Southern Nuclear Operating Company
Vogtle Electric Generating Plant Units 3 and 4
Request for License Amendment:
Module CA03 Details (LAR-13-018)

Module CA03 Details

(LAR-13-018)

Proposed Changes to the Licensing Basis Documents
(LAR-13-018)

UFSAR Section 3.8, Figure 3.8.3-8 (Sheet 3 of 3), [Structural Modules – Typical Design Details]* - Revise Tier 2* information in the IRWST details as described below and shown in the revised figure on the next page and the details of the changes on the pages following the full revised figure:

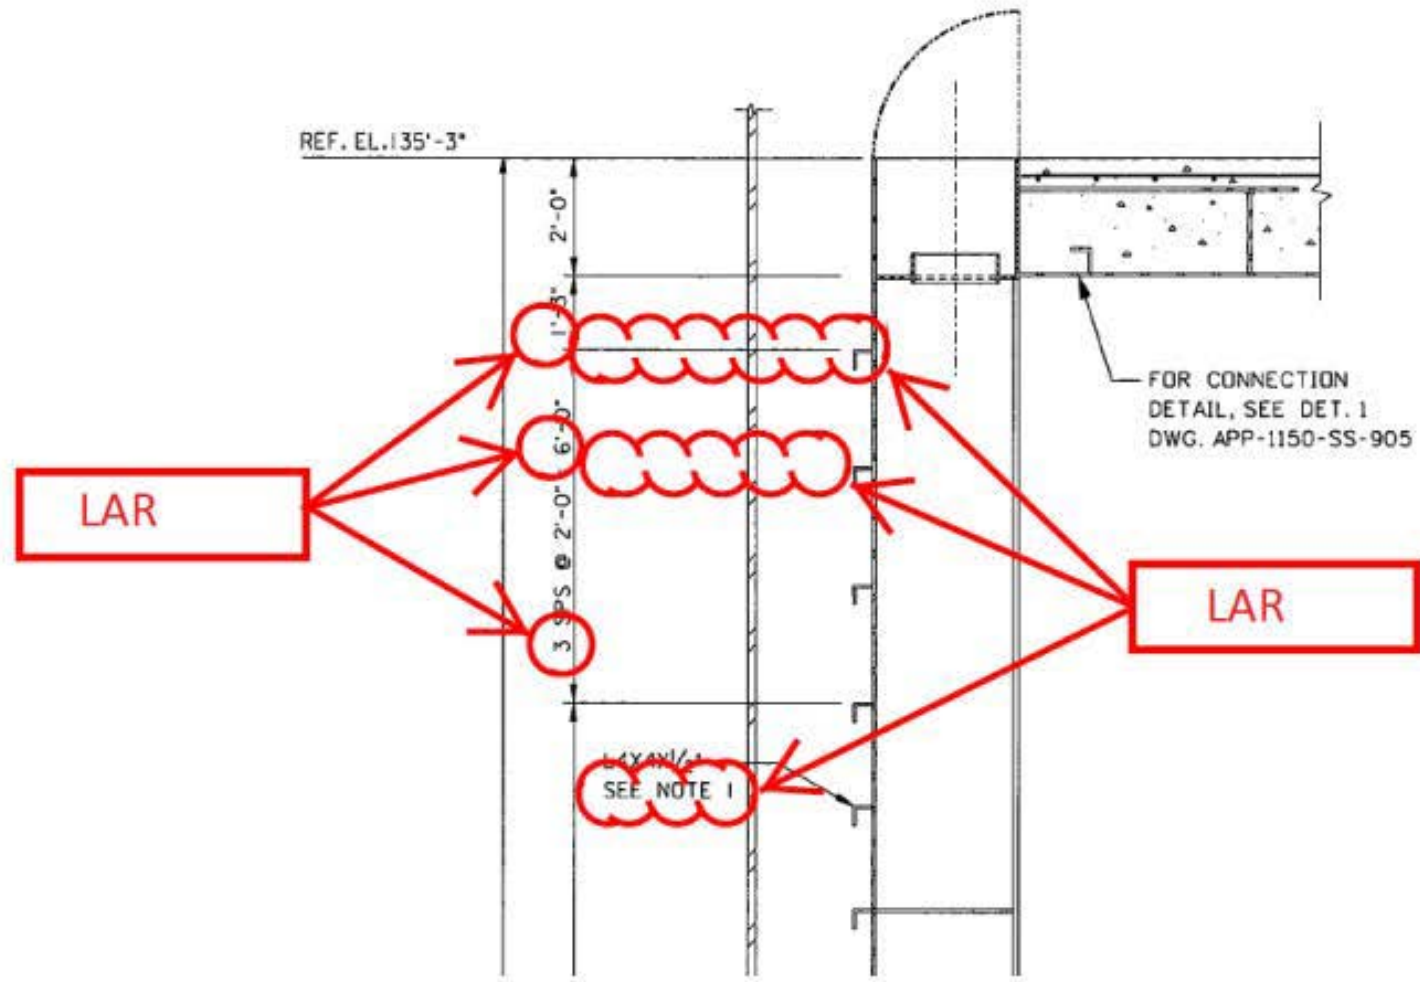
- Revise to remove the callout designation of horizontal stiffeners as “(SST)” and “(SS)” (Left side of Section showing vertical cut of module and in detail showing welding and configuration of horizontal and vertical stiffeners.) The horizontal stiffeners are identified with L4x4x½.
- Revise to include a horizontal angle stiffener external to the pool and revised the elevation information for the top stiffener.
- Revise to add Note 1 to identify that the horizontal stiffener angle size shown is the design minimum.
- Revise the number and arrangement of the shear studs shown on the leg of the module. Revise the note in the lower left of the figure in the portion of the drawing labeled “typical section” identifying stud size and spacing from:

4 VERTICAL ROWS OF ⅞"Φx8"
HEADED STUDS. ONE ROW PER
FACE. 9 STUDS PER ROW (TOT. 36)

- Revise the number of deformed bars anchoring the module in the concrete below the tank by adding a third row of bars to the set of bars near the top of the leg below the tanks floor.
- Revise to add a Note to permit hooks on bars on submodules adjacent to other walls and to permit three bars in the rows of hooked bars.

(42) ⅞"Φx8" HEADED STUDS
ON EACH MODULE SUPPORT
LEG DISTRIBUTED ON THE
FOUR FACES OF EACH LEG
